Applications for resource consents, and a Notice of Requirement for a Designation by Wellington Water Limited on behalf of Upper Hutt City Council, for the construction, operation and maintenance of the structural flood mitigation works identified as the Pinehaven Stream Improvements Project

Statement of Evidence of Alexander Keith Ross

Dated 27 July 2020

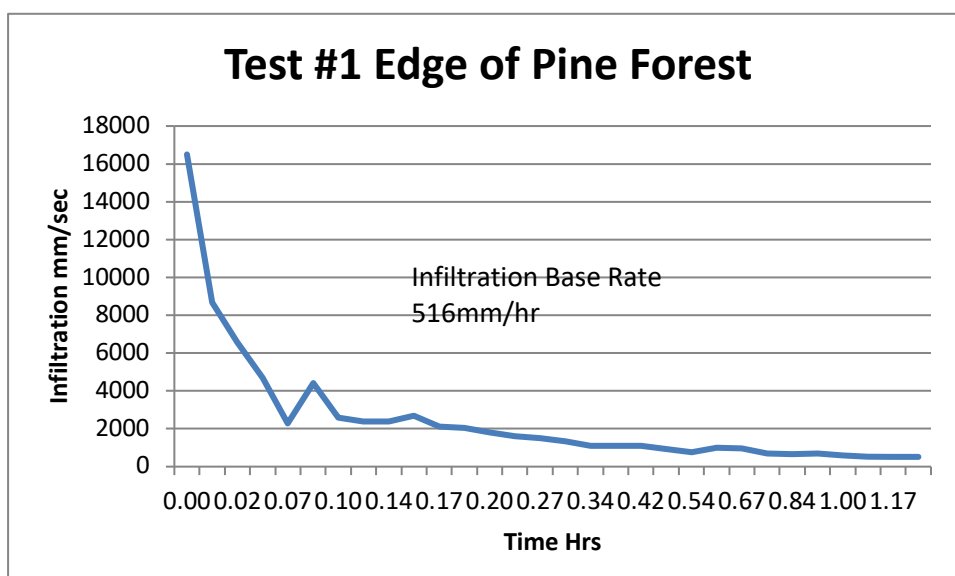
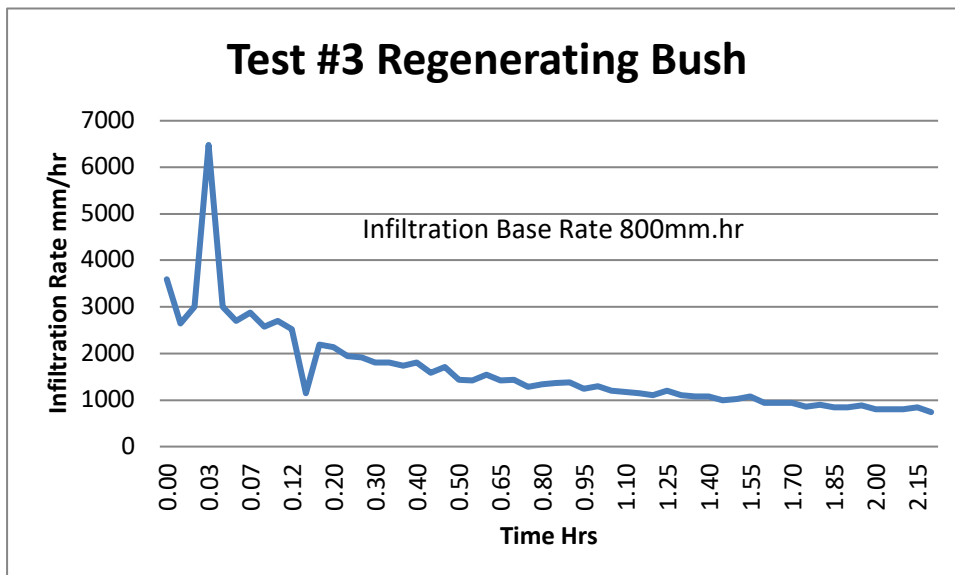
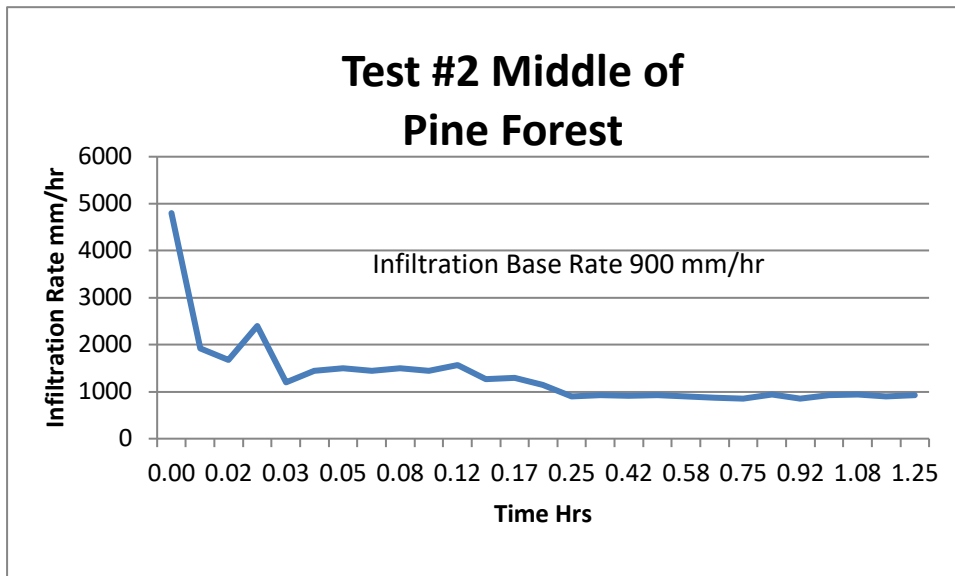
The test results were graphed for tests 1 - 3 of the double Ring Infiltrometer (as shown below), and gave base infiltration rates between 512 - 900 mm/hr for the Bush and forest areas at 27 Elmslie Road.

Setting aside the outlier of Test #6 at 7 sec the average time is 119 sec giving an infiltration rate of 603 mm / hr Which is reasonably consistent with the double ring tests.

**Photograph of secondary flow path caused by undersized culvert and vegetation blocking the channel below the culvert at 122 Pinehaven Road.**

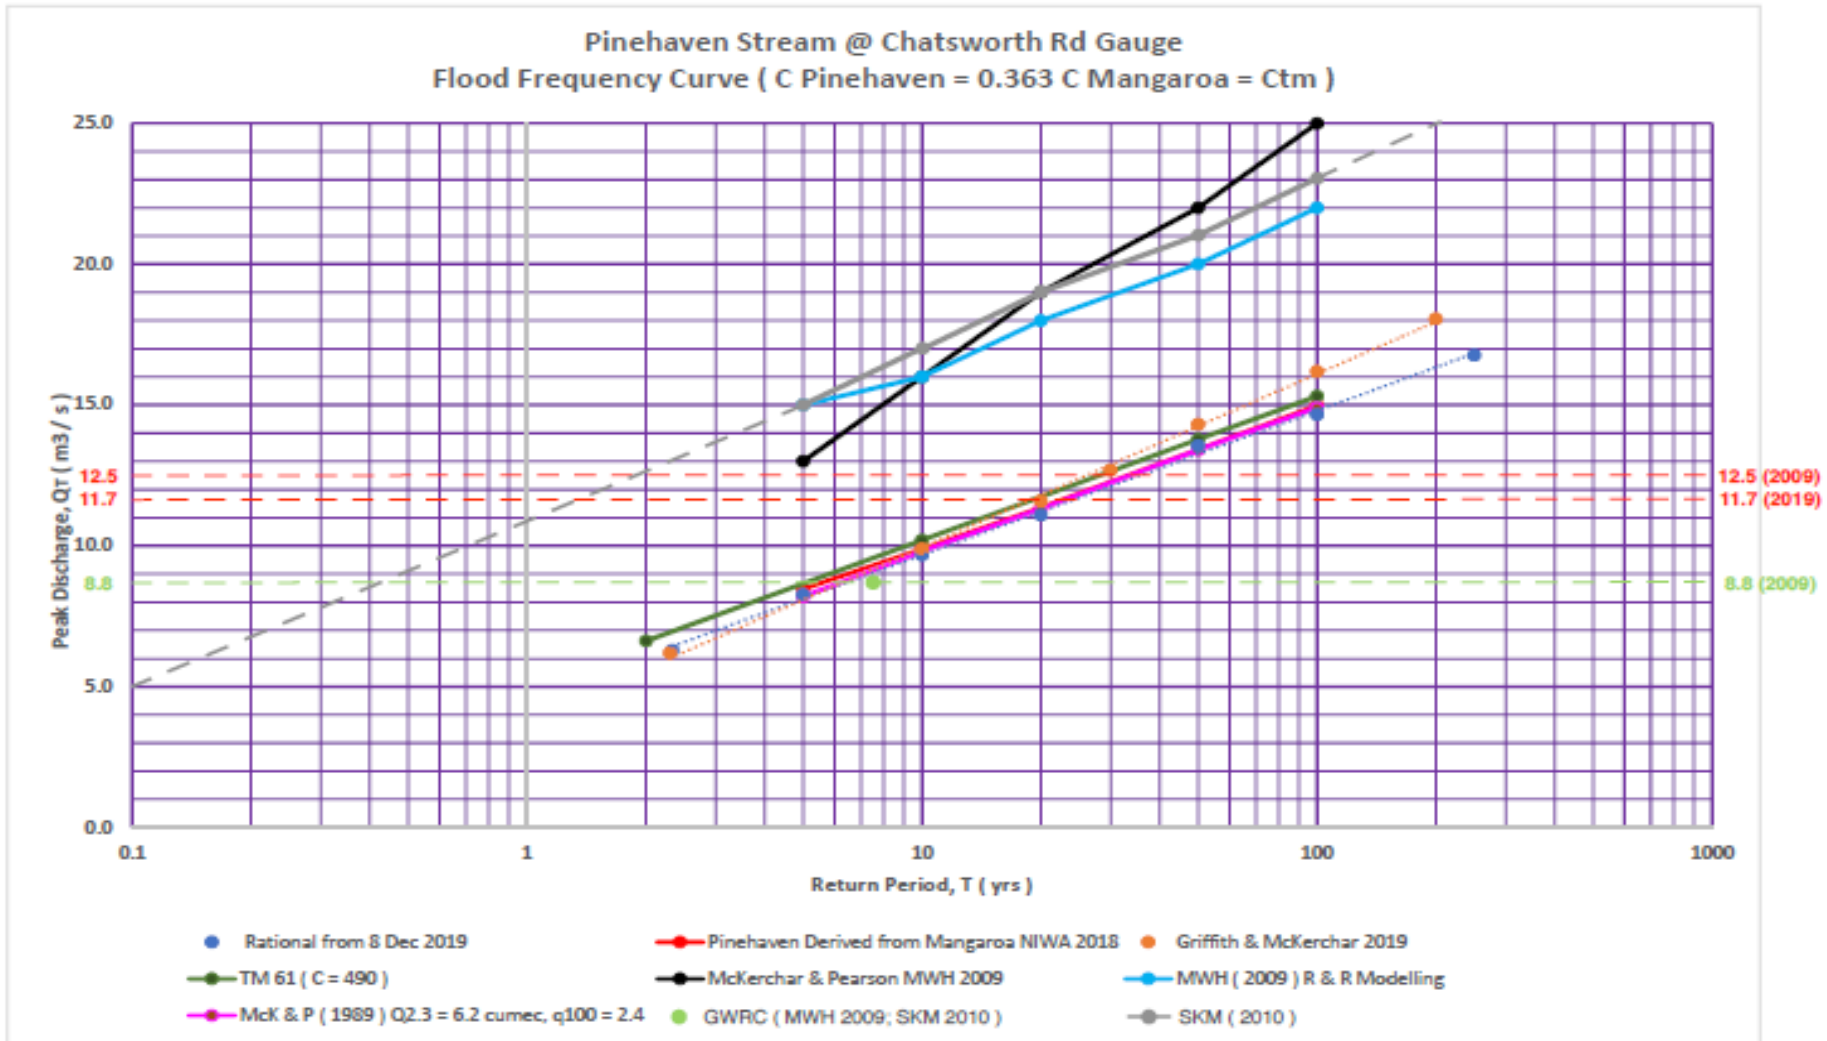
- 5.1 In the application it was stated that the Pinehaven Stream Flood Management Plan includes proposed structural works within the lower reaches of the Stream as well as in the upper catchment.
- 5.2 However, the residents now find out that no works are proposed in the upper catchment where there are several problems that need addressing. This despite the cost ballooning out from \$10M to now over \$40M when interest on loans is factored in. (See photograph attached).
